ADDENDUM NO. 3
TO THE DRAWINGS AND PROJECT MANUAL
FOR
FIRE STATION
RACE TRACK LANE, LAKE CITY, FL
COLUMBIA COUNTY BOARD OF COUNTY COMMISSION

ARCHITECT'S PROJECT NO. 0715

CRAIG SALLEY & ASSOCIATES, ARCHITECTS, GAINESVILLE, FLORIDA

METAL BUILDING DIMENSION PLAN

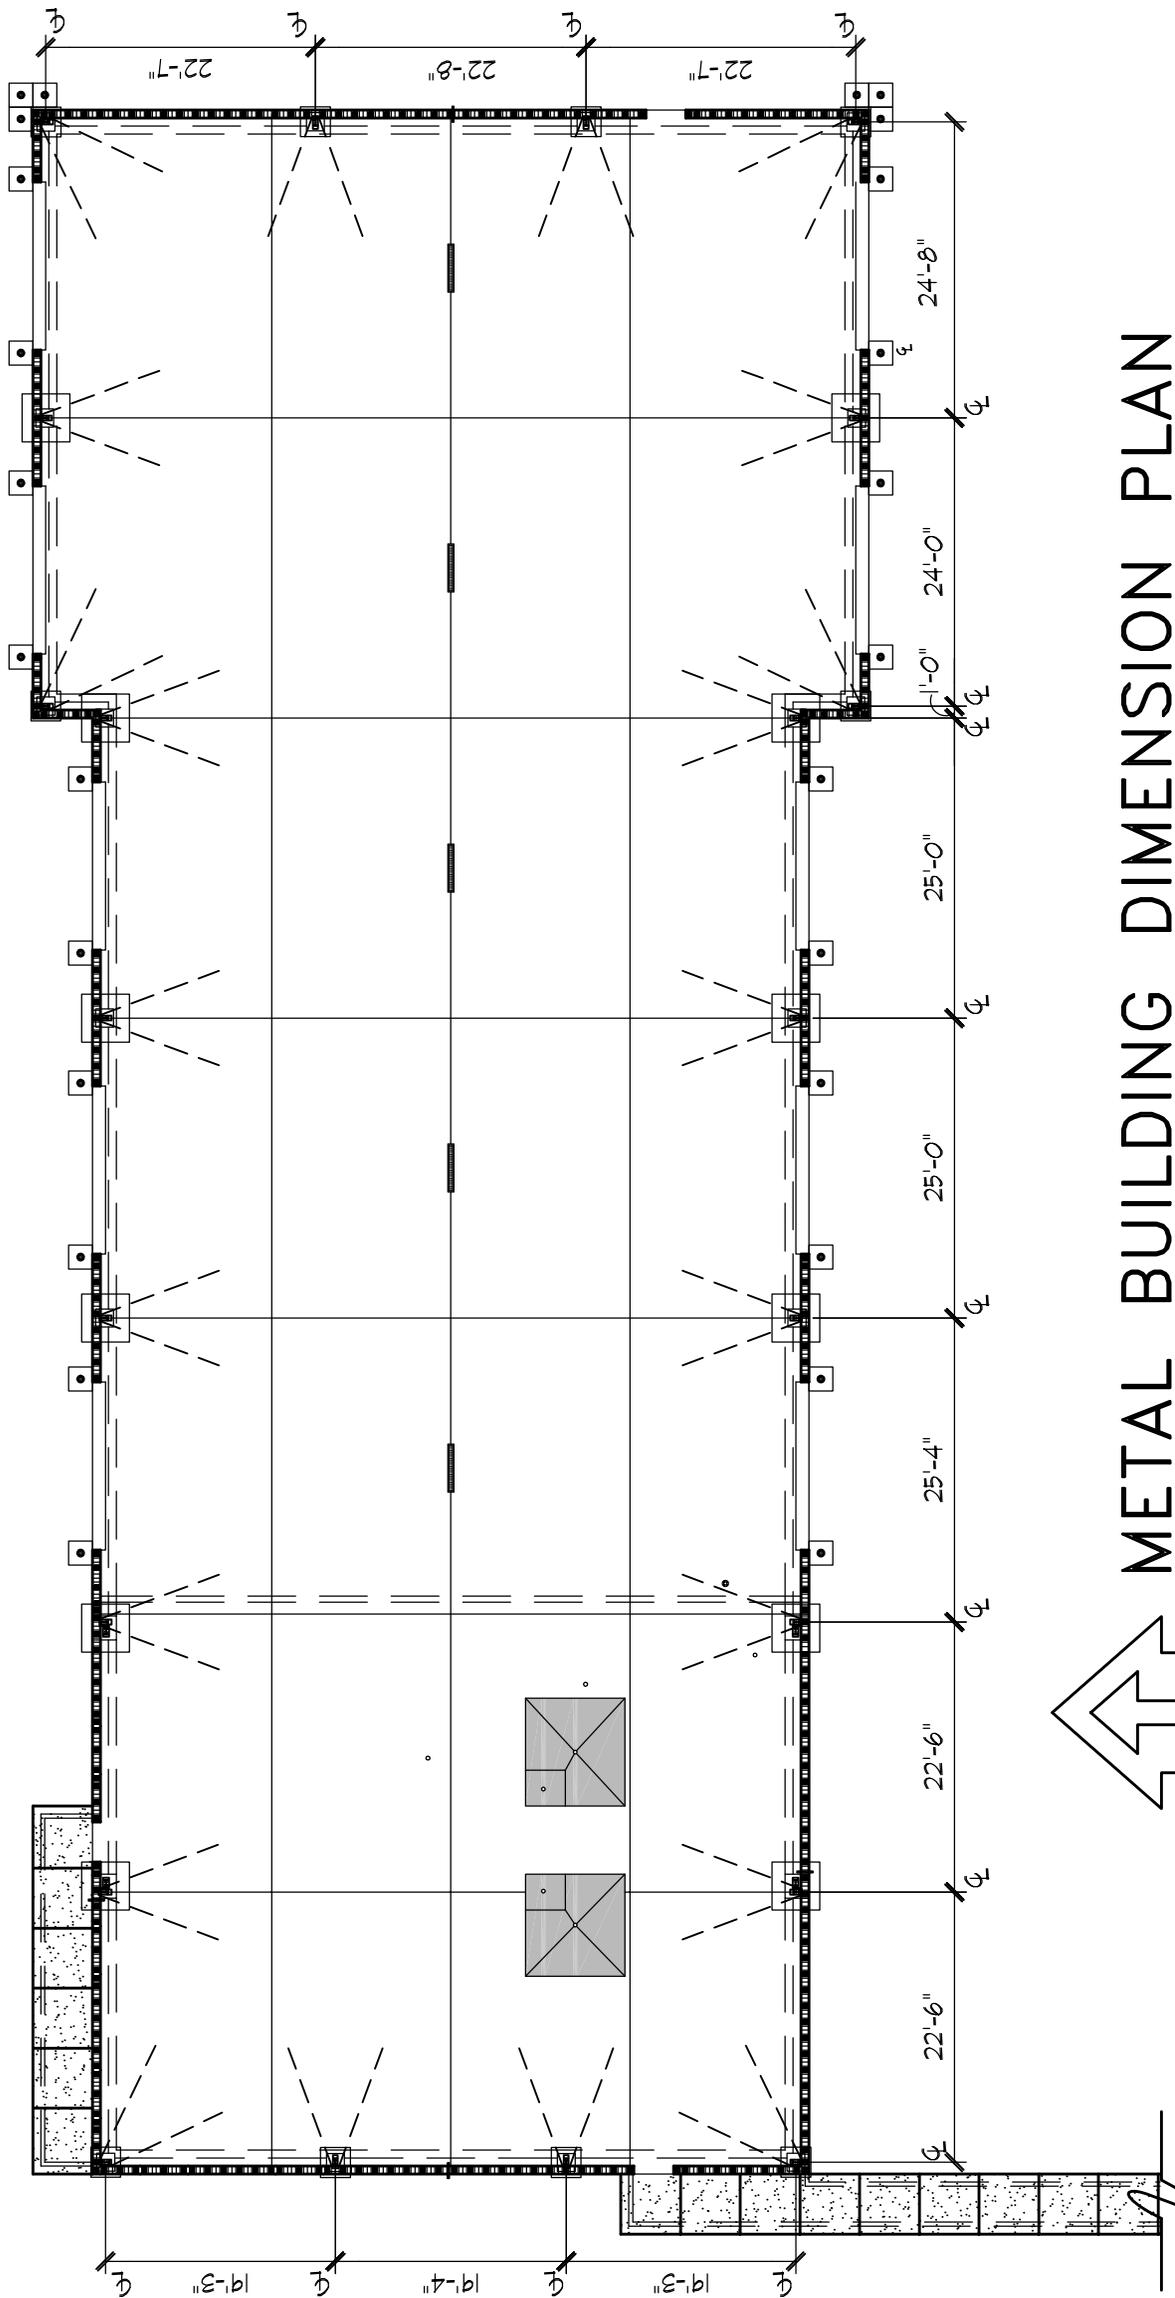
7. **DRAWINGS, SHEET A-1 – FOUNDATION PLAN:** When the Foundation Plan was plotted, the dimension layer was not turned on. Refer to Attachment “A” for dimensions for the prefabricated metal building frame.
